## **Technical Bulletin 037**

## Model 46 Walking Axle Hyper-extension

This technical bulletin relates to Model 46 machines built before January 2018.

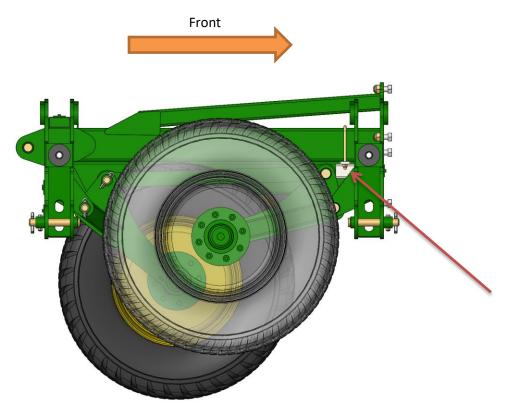
Under certain conditions it is possible for the rear walking axle to travel down too far resulting in the axle going over center in its travel.

U-bolt the supplied block as shown on the front of the center frame on both sides, this will limit the travel of the walking axle preventing hyper-extension.
